### ADDENDUM NO. 1

**RE: Item #3, October 7, 2015 Letting - NH 0212(156)306, NH 0281(99)152, PCN 023T, 03HS, Spink County - Cold Milling Asphalt Concrete, Asphalt Concrete Resurfacing, ADA Upgrades, Signal & Roadway Lighting**

The following addenda to the plans shall be inserted and made a part of your proposal for the referenced project.

# SIGNAL TIMING

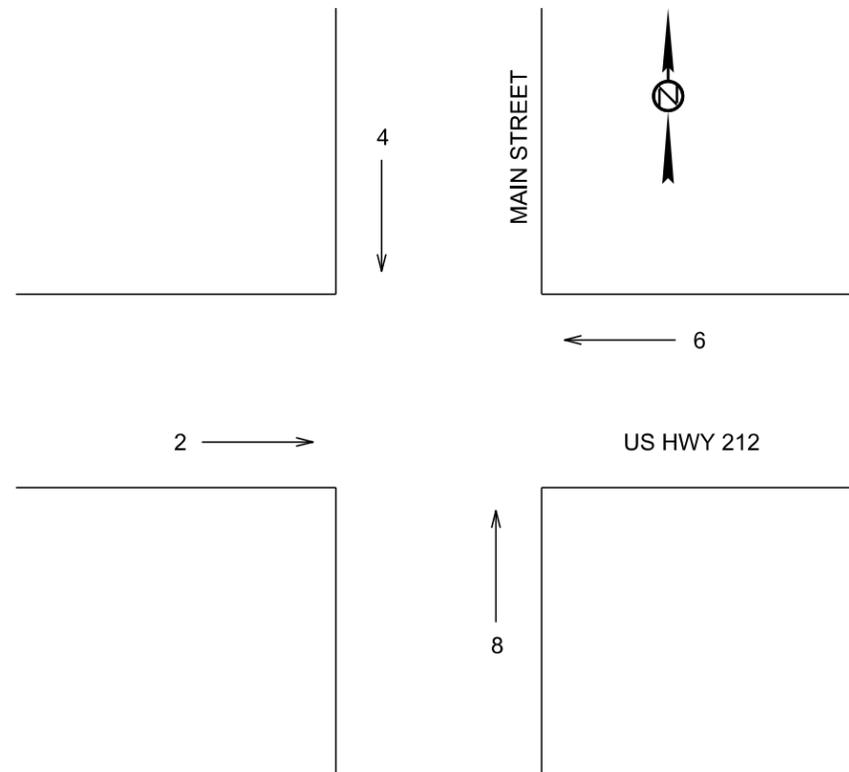
**Sheets L12 & L24:** Items for "Sawed-In, Preformed Detector Loop" were added and items "Preformed Detector Loop" were removed from table.

DETECTOR SETTINGS								
DETECTOR LABEL	AMPLIFIED CHANNEL DETECTOR	DETECTOR TYPE	DETECTOR OPERATION			LOCKING CALL	MOVEMENT CALLED	MOVEMENT EXTENDED
			CALLS & EXTENDS	CALLS ONLY	EXTENDS ONLY			
N1, N2, N3	1	SAWED-IN, PREFORMED	X				4	4&8
N4, N5	2	SAWED-IN, PREFORMED	X				4	4&8
S1, S2, S3	3	SAWED-IN, PREFORMED	X				8	4&8
S4, S5	4	SAWED-IN, PREFORMED	X				8	4&8
E1, E2, E3	5	SAWED-IN, PREFORMED	X				6	2&6
W1, W2, W3	6	SAWED-IN, PREFORMED	X				2	2&6
E4, E5	7	SAWED-IN, PREFORMED	X			X	6	2&6
W4, W5	8	SAWED-IN, PREFORMED	X			X	2	2&6

SD DOT	SAWED-IN DETECTOR LOOP	PLATE NUMBER 635.71
		Sheet 1 of 1

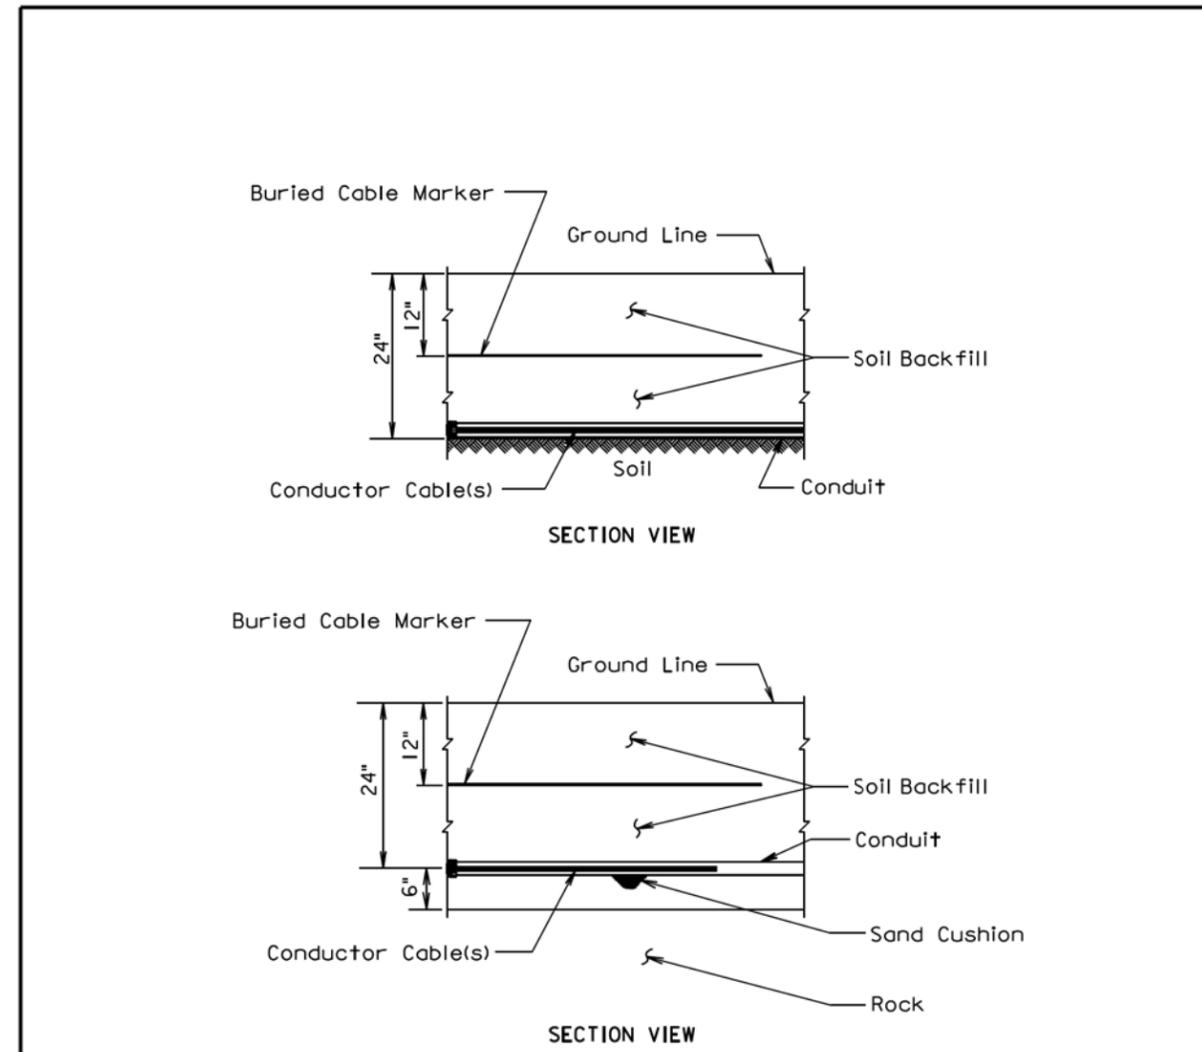
**Sheet L36:** The standard plate for PREFORMED DETECTOR LOOPS (635.70) was replaced by the standard plate for SAWED-IN DETECTOR LOOP (635.71).
